Request for Review

Please find below the response to the review formulated for the CDM project with the registration number 1905. In case you have any further inquiries please let us know how we can kindly assist you.

Response to the CDM Executive Board

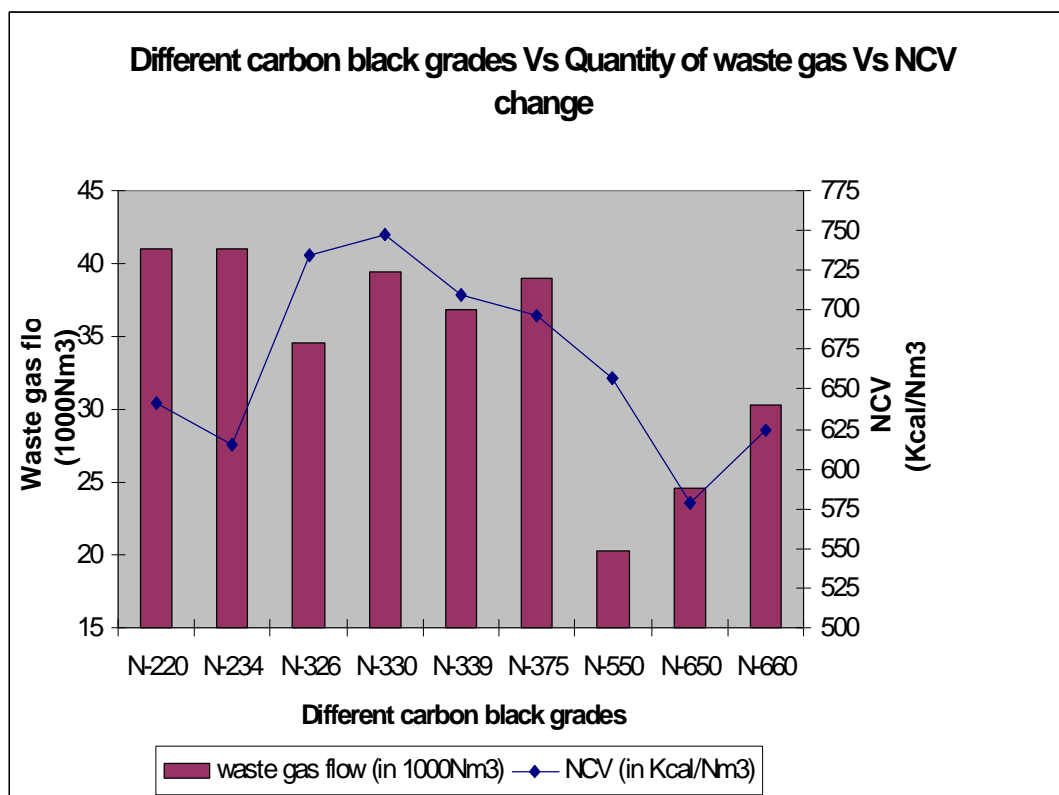
HTC produces different grades of carbon black³ to meet the market requirements. The quality and quantity of waste gas would vary depending upon the grades of carbon black produced. Hence, there will be fluctuation of waste gas in terms of quality and quantity which may affect the downstream equipments.

The Net Calorific Value of the waste gas and its variation with respect to different carbon black grades is provided in the below graph.

The huge variation in the waste gas depending upon the grade change proves to be a challenge for effective operation of waste gas based power generation.
